NOTICE OF ADDENDUM

ADDENDUM NO. 4

CONTRACT NO. 7528, PROJECT NO. 10305 NAKOOSA TRAIL FLEET/FIRE/RADIO SHOP FACILITY

ENLARGED ENTRY CANOPY LOW FRAMING PLAN AREA E
1/4" = 1'-0"

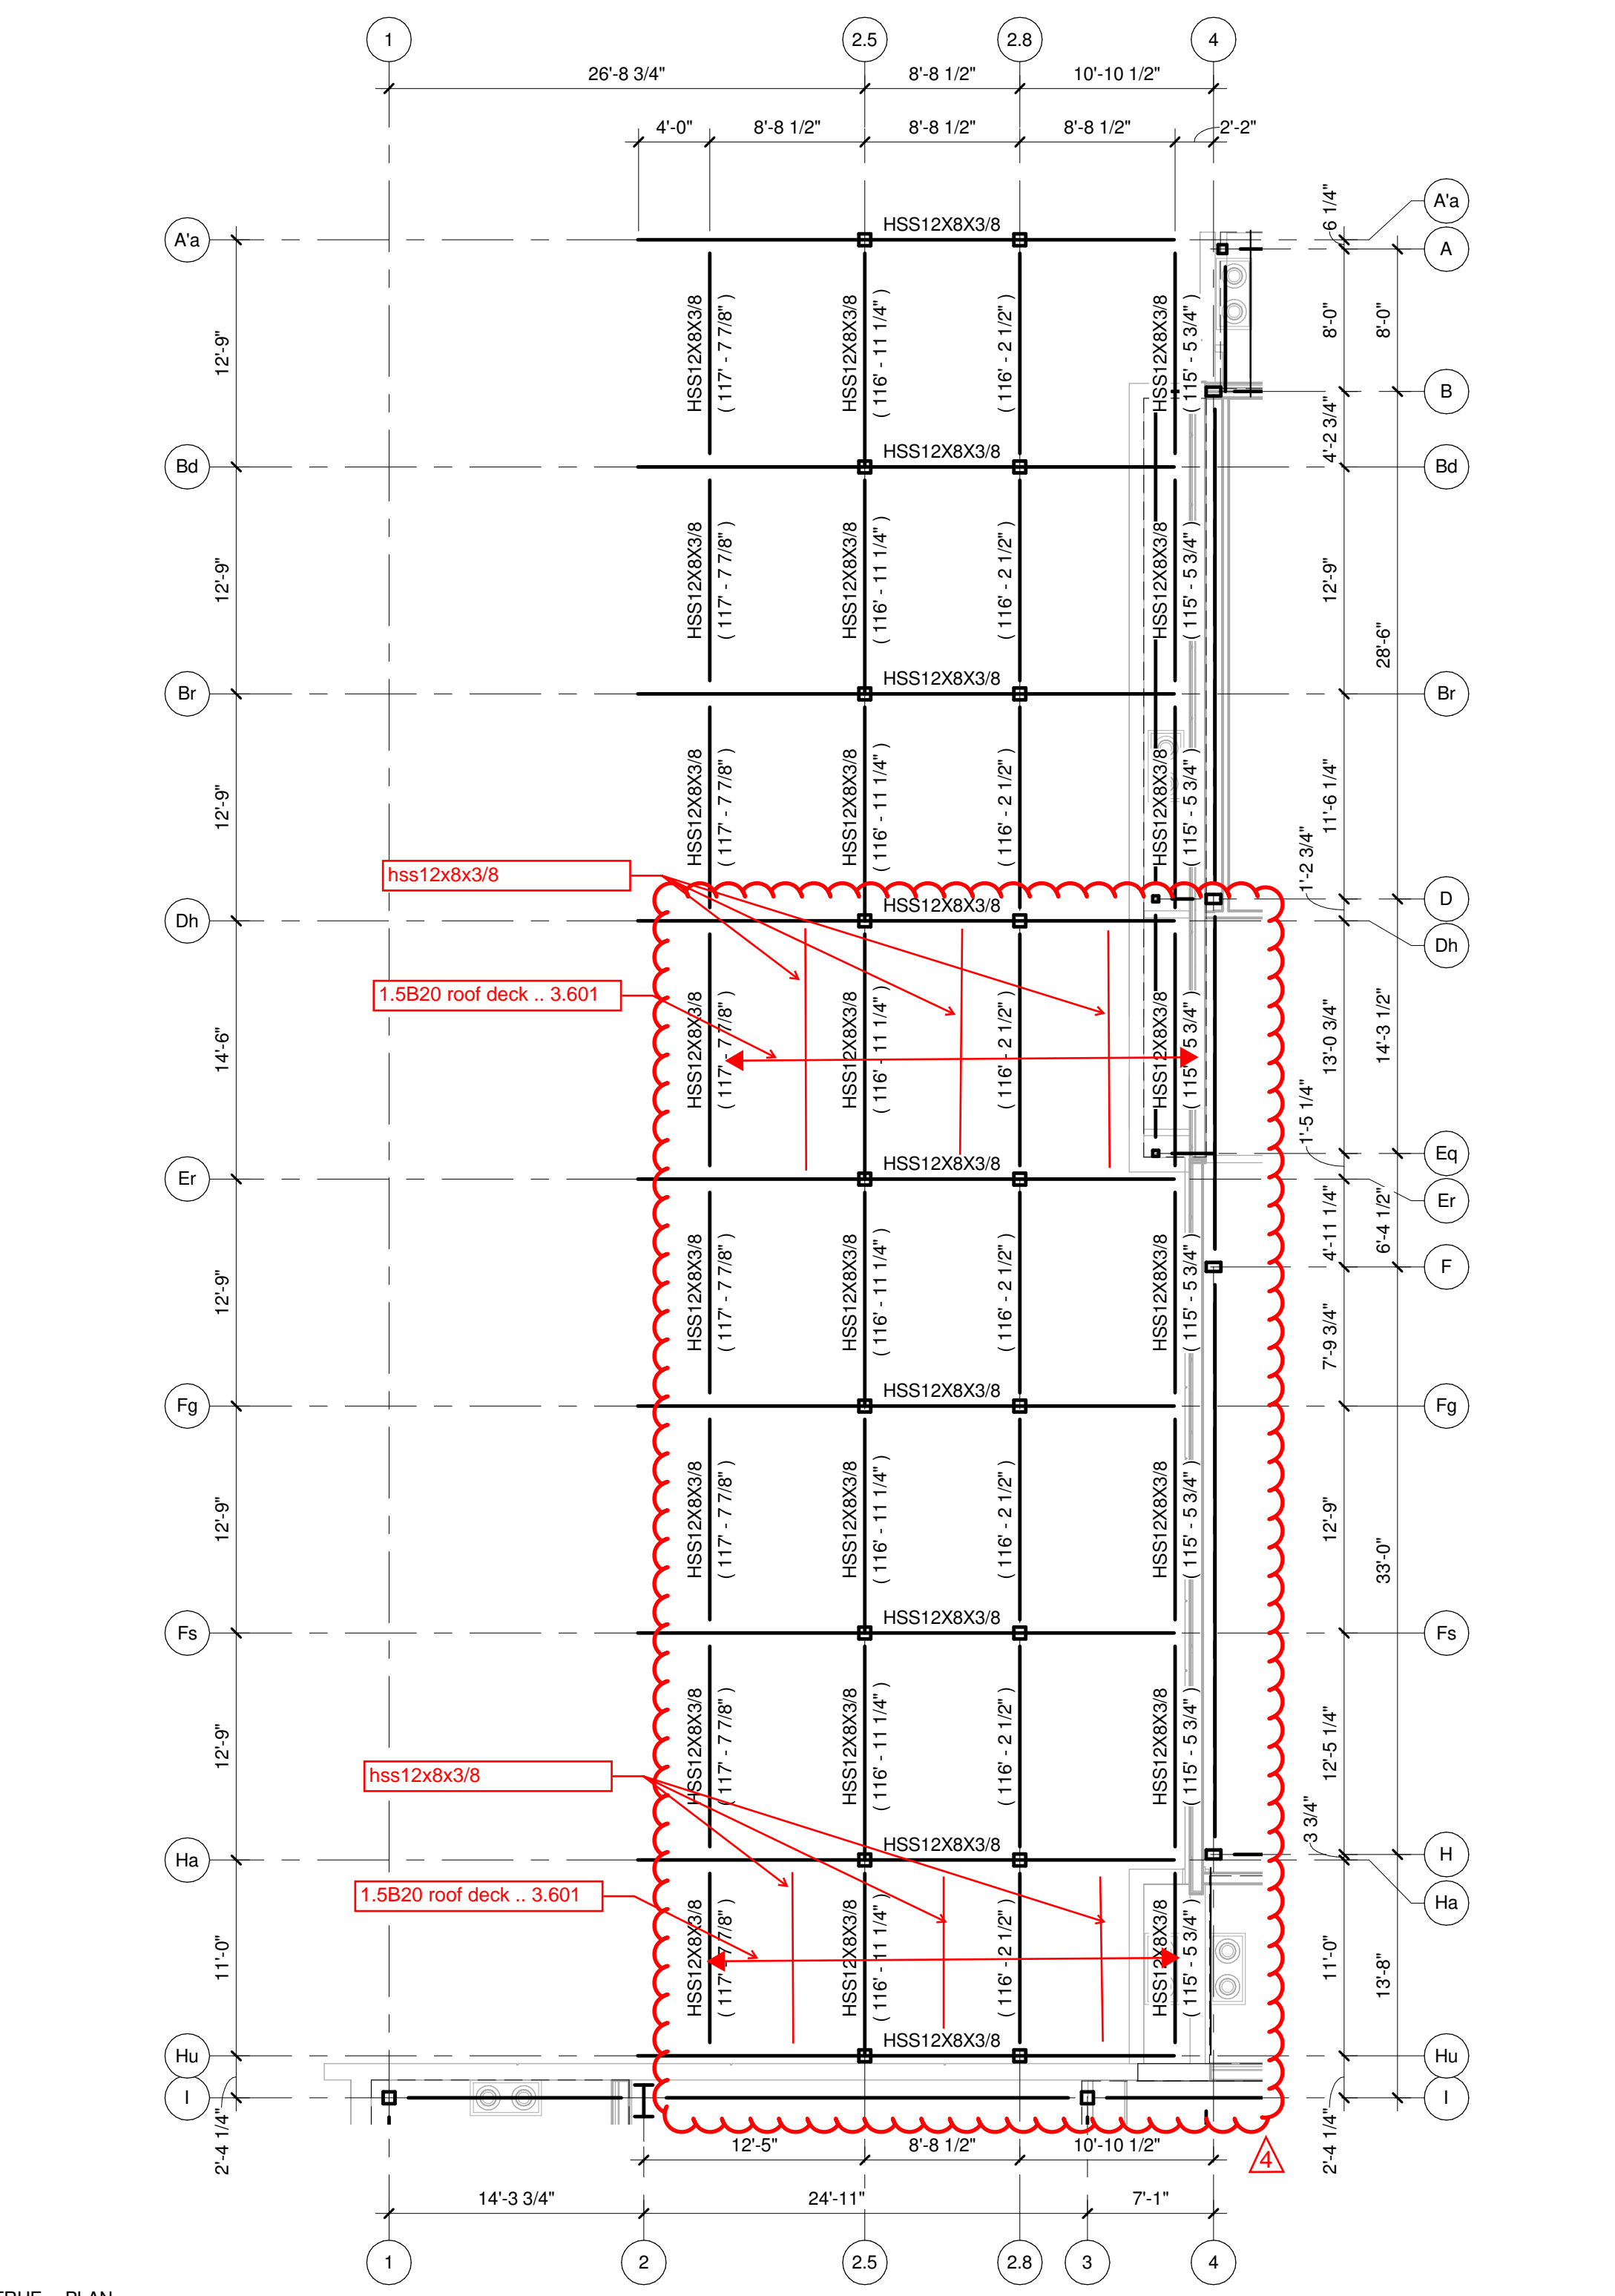
- A. **MODIFIED** A-126 MISC ROOF PLANS with markups of support angle locations at the intermediate sidelap of MS-3 perforated panels. See attached drawing sheet.
- B. **MODIFIED** A-510 CANOPY DETAILS with support angle at intermediate sidelap of perforated panels.
- C. **MODIFIED** S-451 MISCELLANEOUS FRAMING PLANS. See attached drawing sheet.
- D. **MODIFIED** S-601 STRUCTURAL SCHEDULE Add structural column schedule general note:
1. ALL BASEPLATES ARE 3/4" THICK UNO. (Drawing sheet not attached.)
